**National Committee on
Seismic Design Parameters (NCSDP)
for River Valley Projects**

**MINUTES
OF
32nd MEETING
(12th July, 2017)**

**MINUTES OF THE 32ND MEETING OF
NATIONAL COMMITTEE ON SEISMIC DESIGN PARAMETERS FOR RIVER VALLEY PROJECTS
HELD ON 12TH JULY, 2017 AT CWC, NEW DELHI**

32.3.4 Kirthai-II Hydro Electric Project, Jammu & Kashmir

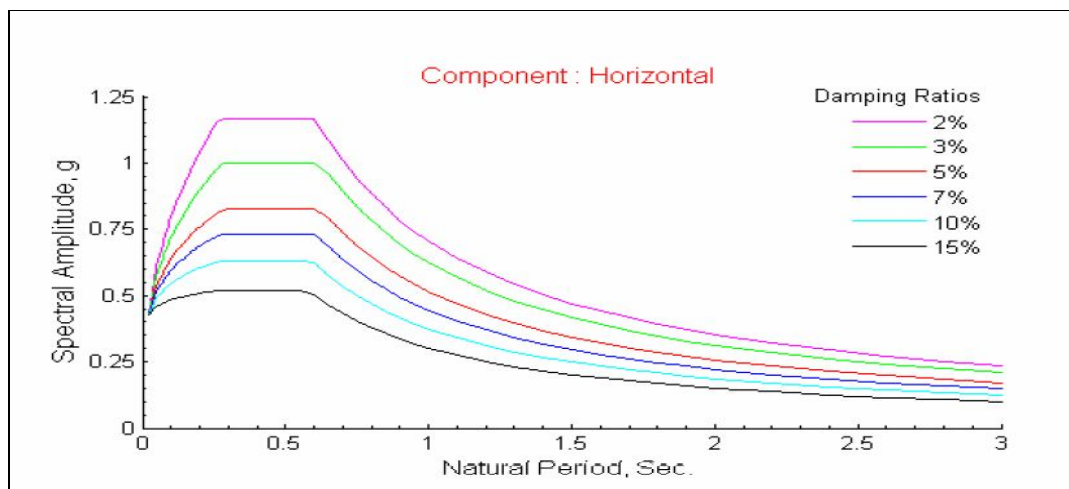
During discussion, the representatives of IIT Roorkee mentioned that PGA values obtained for Kirthai-II HE Project are on higher side as compared to Kirthai-I HE Project as both the sites are situated only 13 km away. The PGA values obtained for Kirthai-II HE Project are 0.56g for horizontal and 0.41g for vertical component for MCE condition whereas the PGA values obtained for Kirthai-I HE Project are 0.48g for horizontal and 0.32g for vertical component for MCE condition. The study report of the Kirthai-I HE project had already been approved in the last meeting of NCSDP. In response, representatives of CWPRS, Pune clarified that these studies are site-specific and depends on several other parameters such as V_{s30} , type of geology, Hanging wall/foot wall etc. The study was deliberated and it was suggested by the Committee to have a look on other projects carried out in the same region on either side of MCT in vicinity of these two projects and review the study of Kirthai-II HE Project accordingly. Further, it was requested from IIT Roorkee to provide the requisite details of other approved

projects in the vicinity of the project carried out by them and IIT Roorkee agreed for the same. Accordingly, it was decided that CWPRS will review the study report and apprise the Committee in the next meeting for consideration. Further, the project authorities were also suggested to carry out MEQ studies as the dam height is 121 m.

After brief deliberation, the Committee decided that CWPRS, Pune will review the study report of Kirthai-II HEP vis-à-vis Kirthai-I HEP and other projects in the vicinity. The project will be considered in the next meeting accordingly.

**ESTIMATION OF SITE-SPECIFIC DESIGN GROUND MOTION FOR TAMANTHI
HYDRO ELECTRIC PROJECT, MYANMAR**

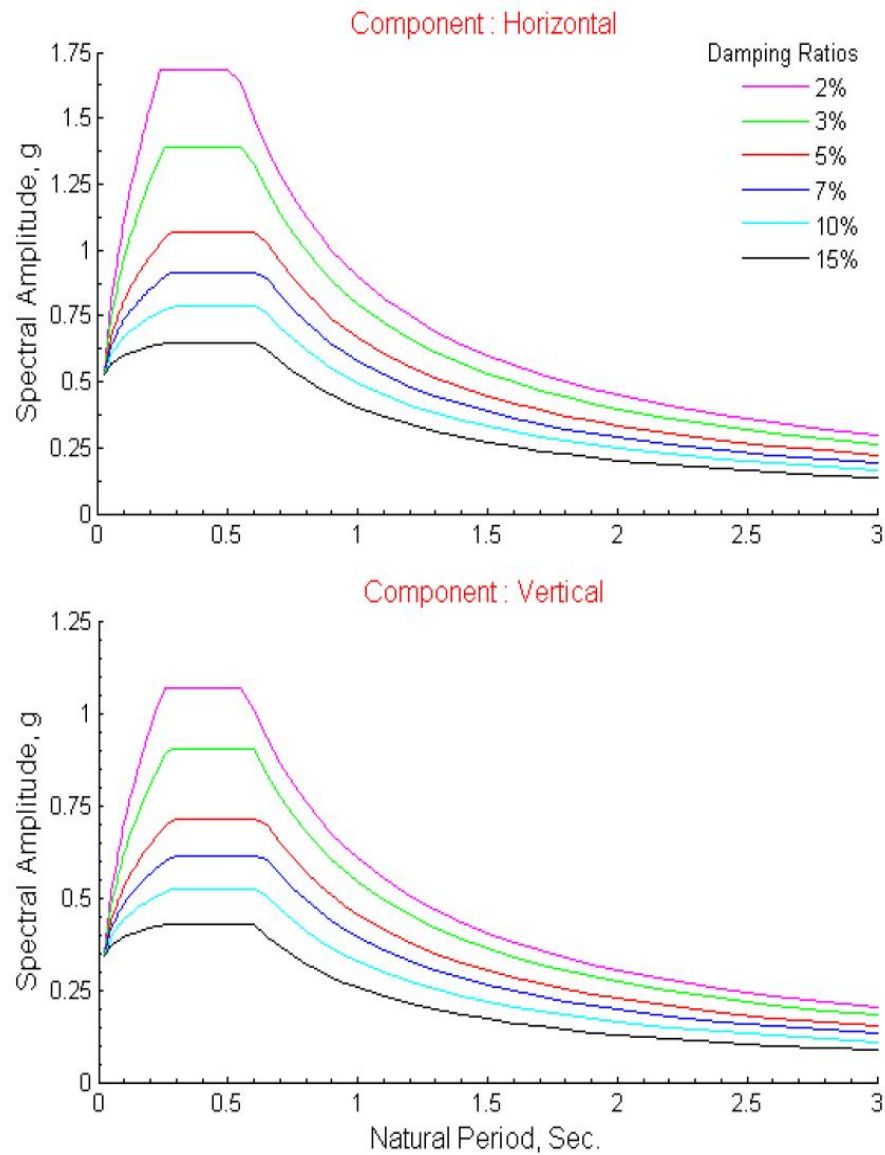
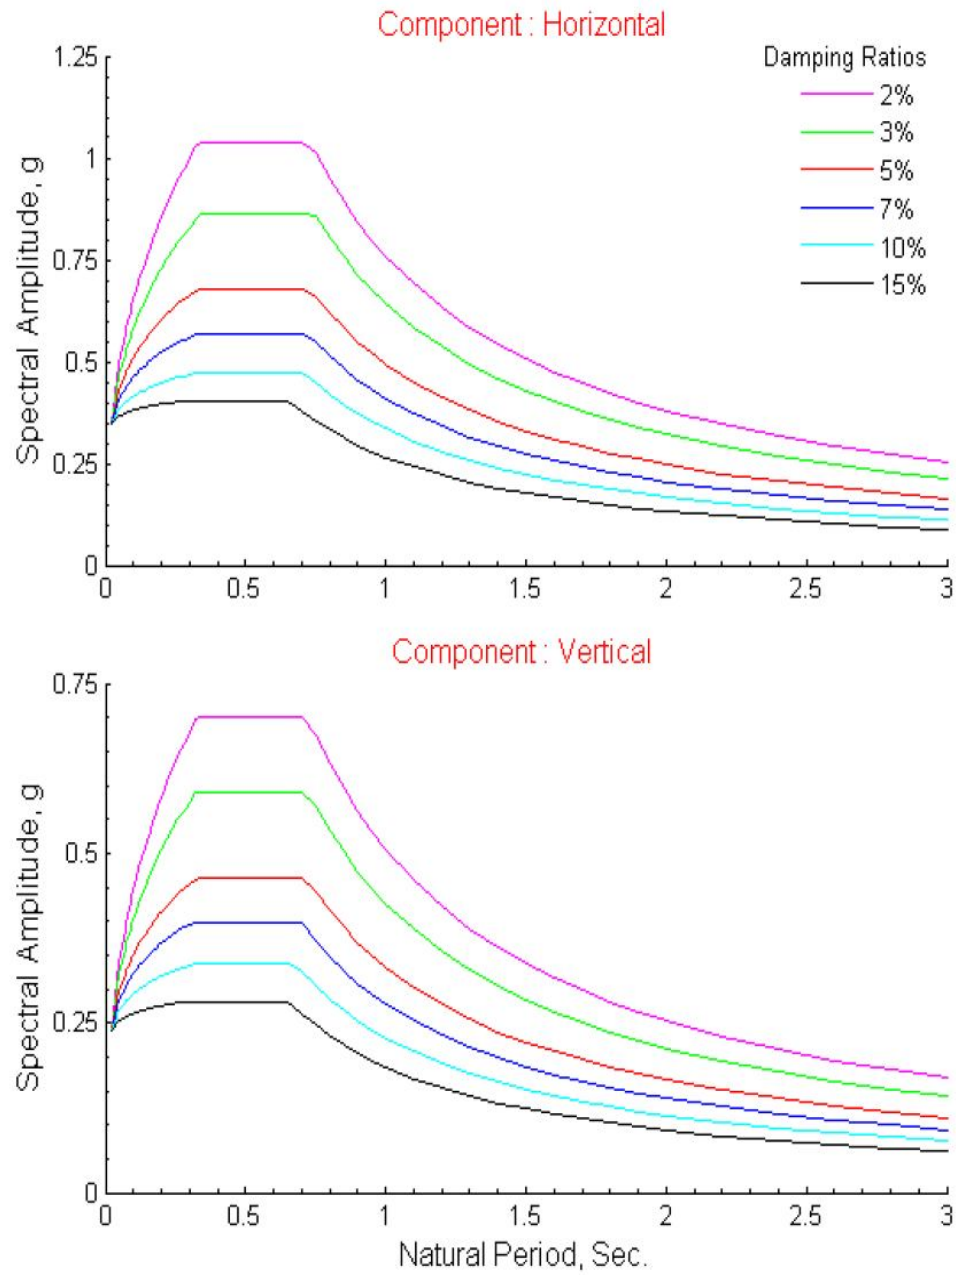
A presentation on the study report was made by the project authorities. During discussion, Dr Yogendra Singh, IIT Roorkee suggested that the shape of design response spectra needs to be smoothened in the study reports of CWPRS, Pune. He further clarified that the studies carried out by CWPRS are as per NCSDP guidelines, however, keeping in view of engineering perspective, the design response spectra may be modified with flattened peak. In view of this, the Committee decided that design response spectra should be modified accordingly. The representatives of CWPRS agreed to modify the design response spectra and ***submitted the modified the design response spectra along with updated study report vide their letter no.324/41/2017-ES/644 dated 17.08.2017 (Annexure-II)***. Further, The Committee also suggested that the seismic zone of the project shall be considered as Zone-V and the seismic co-efficient (α_h & α_v) shall be taken as 0.24 and 0.16 respectively.

After brief deliberation, the Committee accorded approval to the study report of Tamanthi Hydro Electric Project, Myanmar incorporating the modified design response spectra. The summarized seismic design parameters of the approved report are as under:

As per the decision taken in the 32nd NCSDP meeting held on 12th July, 2017 to provide flat Design Response Spectra in the Site-specific Seismic Design Parameters study reports, the following technical reports are modified by including flat Design Response Spectra and the soft copies of the same are submitted herewith.

**ESTIMATION OF SITE-SPECIFIC SEISMIC DESIGN PARAMETERS FOR GORIGANGA IIIA
HYDROELECTRIC PROJECT SITE, UTTARAKHAND**

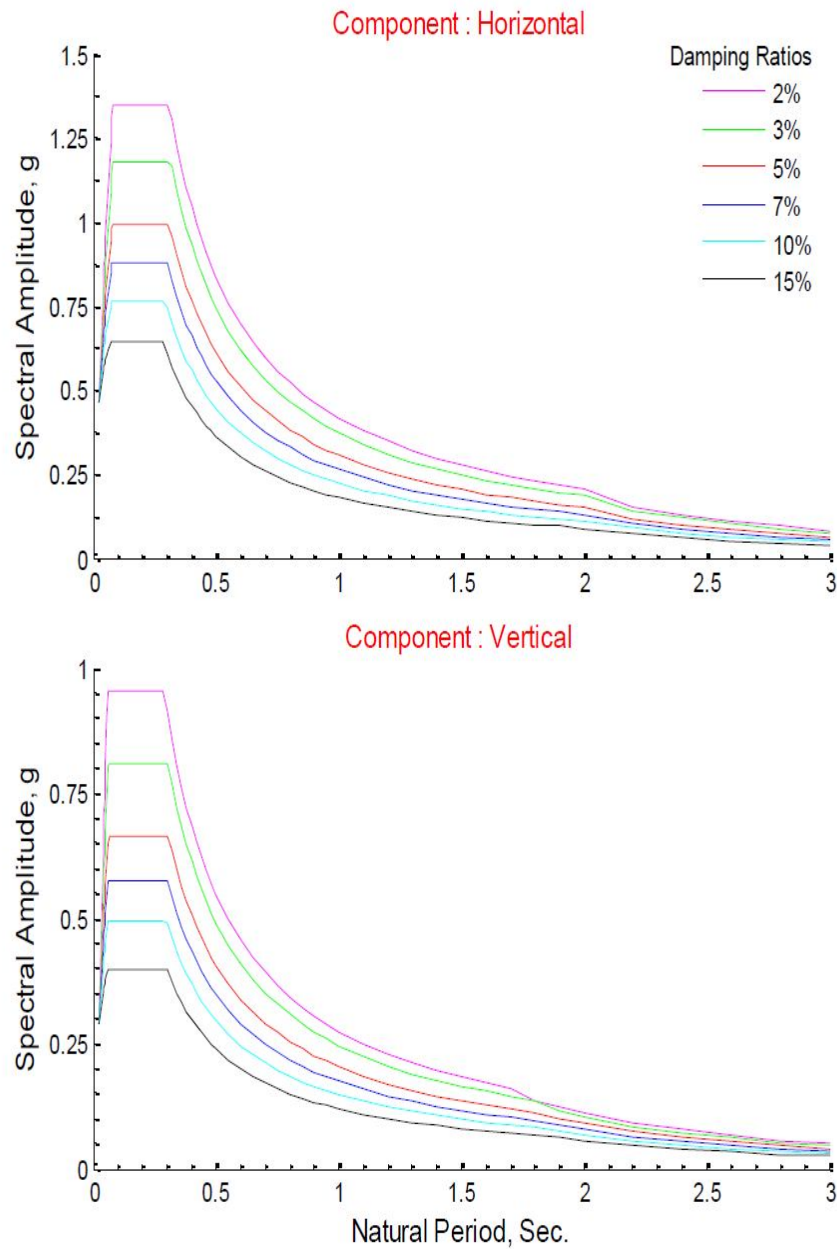
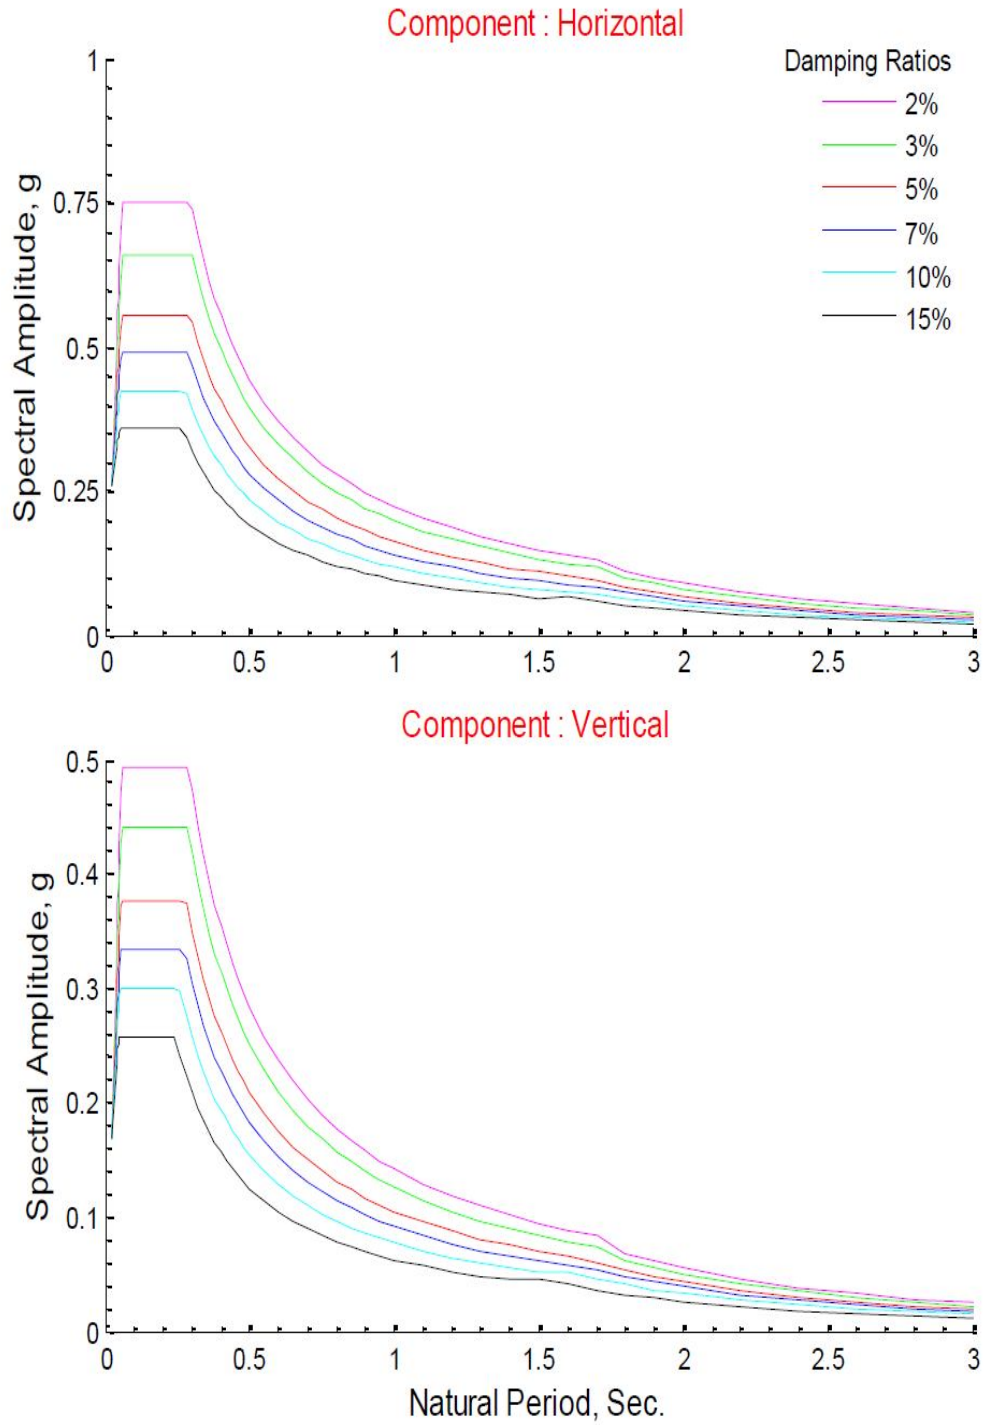
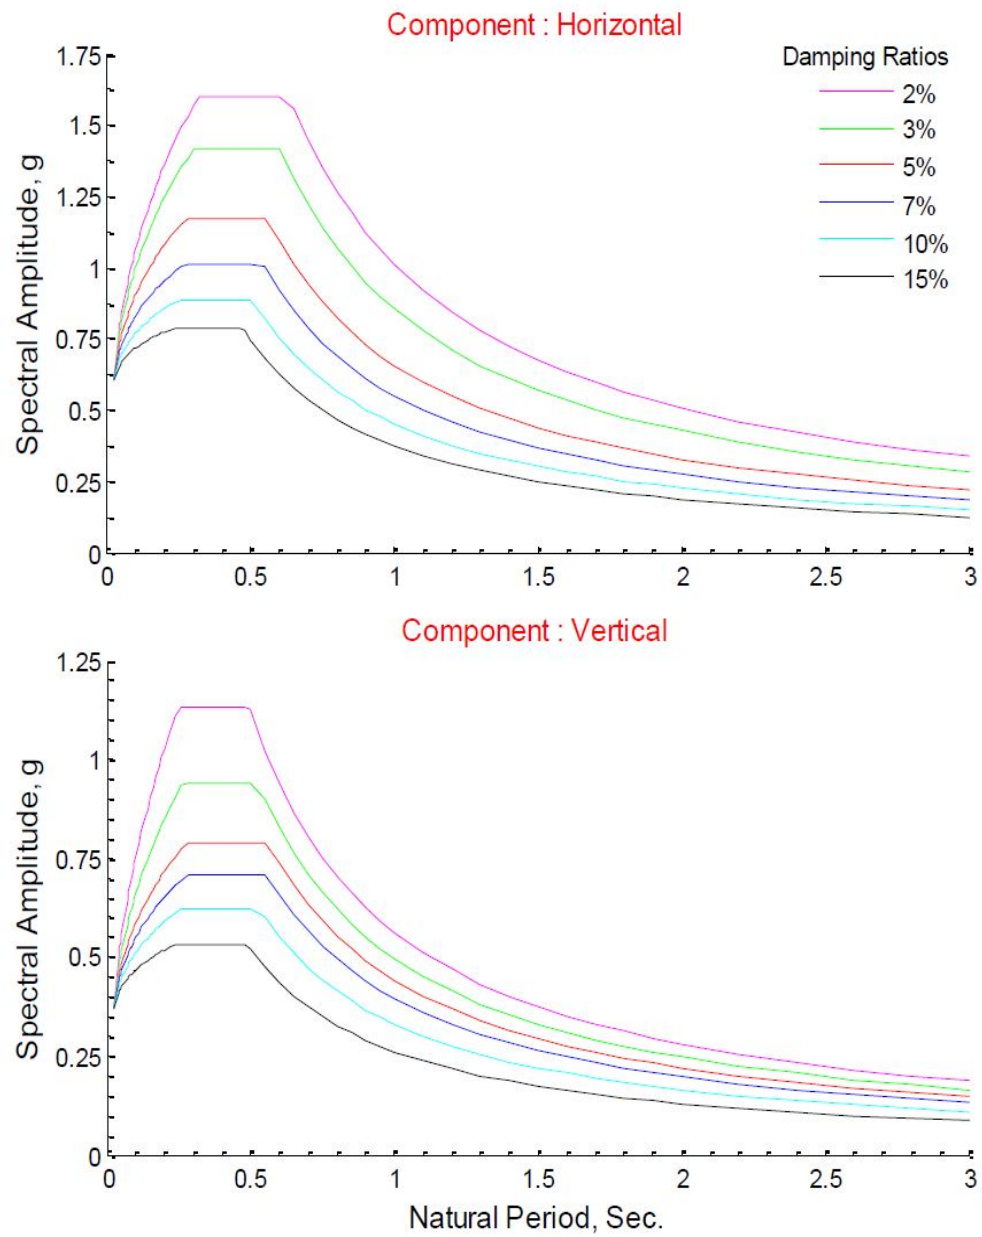
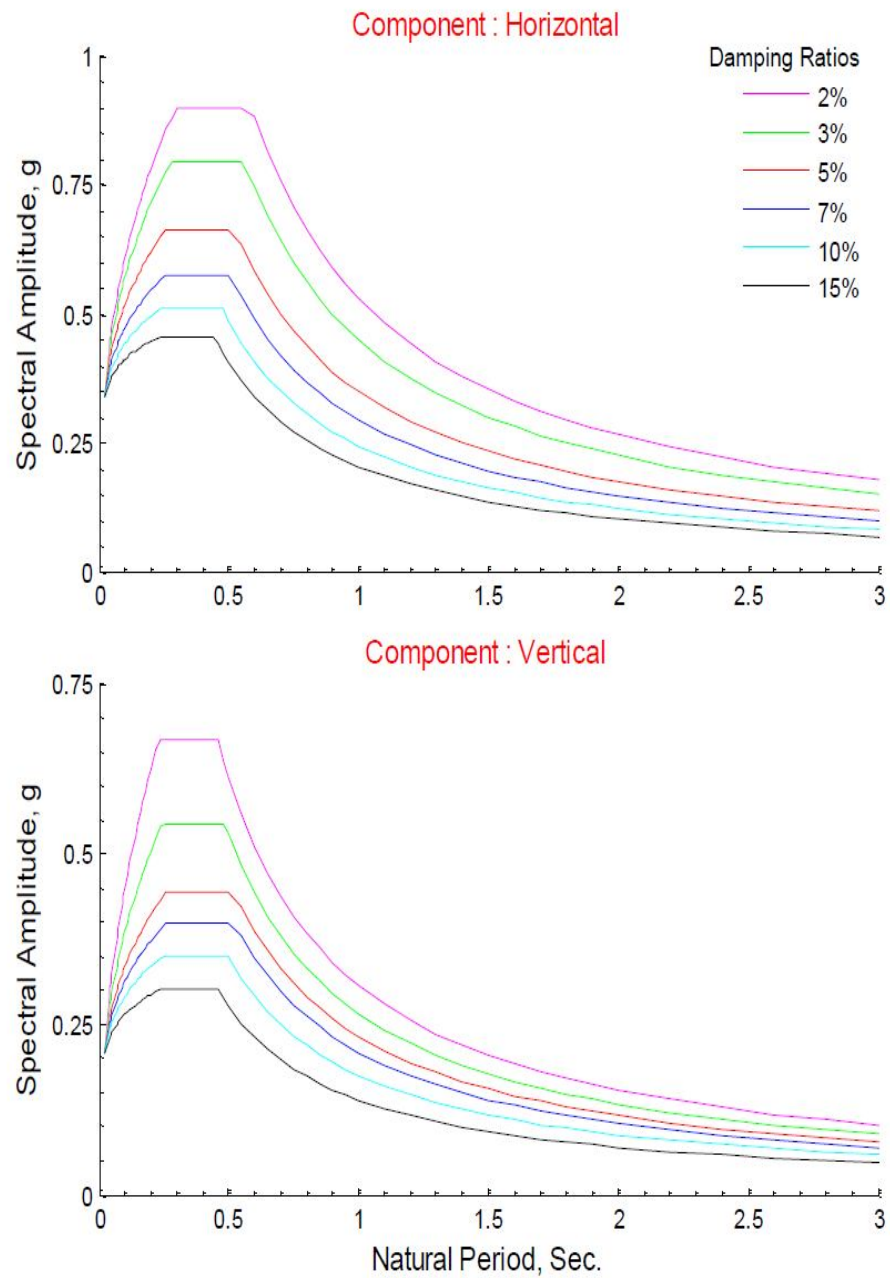
A presentation on the study report was made by the project authorities. During the discussion, it was mentioned that the design response spectra should be modified as discussed under item 32.3.1 above. Accordingly, CWPRS, Pune has supplied the modified design response spectra alongwith modified report vide their letter dated 17.08.2017 (**Annexure-II**).

**ESTIMATION OF SITE-SPECIFIC SEISMIC DESIGN PARAMETERS FOR
KULSI MULTI PURPOSE PROJECT, ASSAM**

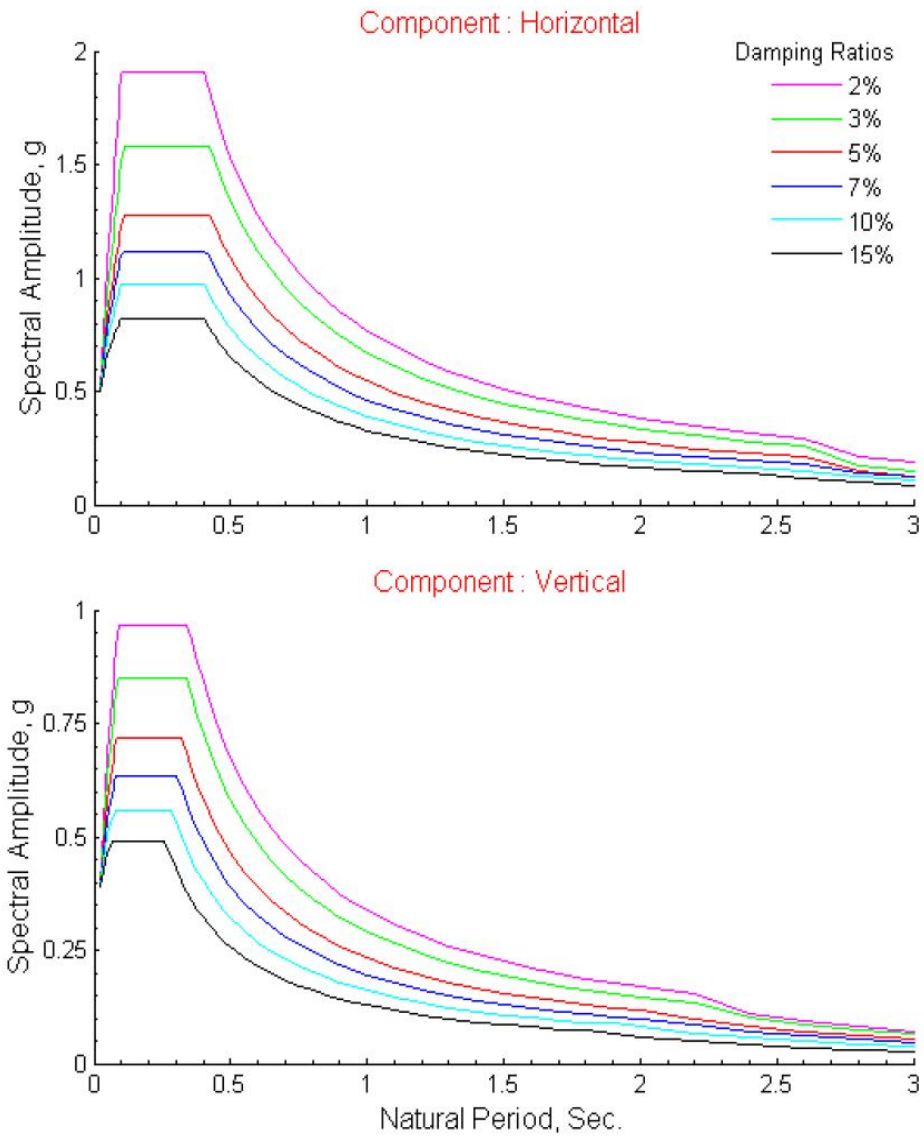
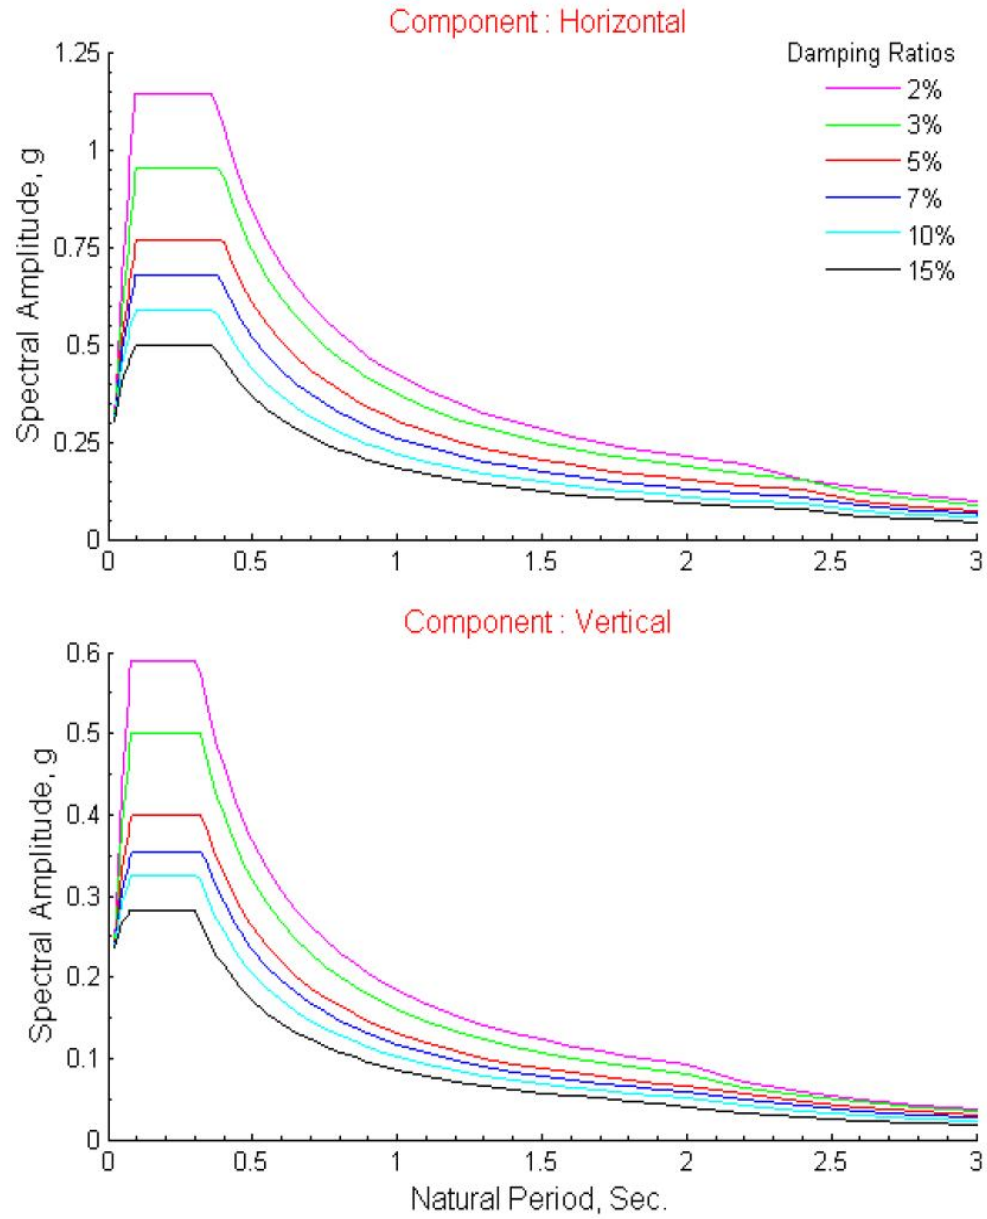
A presentation on the study report was made by the project authorities. During the discussion, it was mentioned that the design response spectra should be modified as discussed under item 32.3.1 above. Accordingly, CWPRS, Pune has supplied the modified design response spectra alongwith modified report vide their letter dated 17.08.2017 (**Annexure-II**).
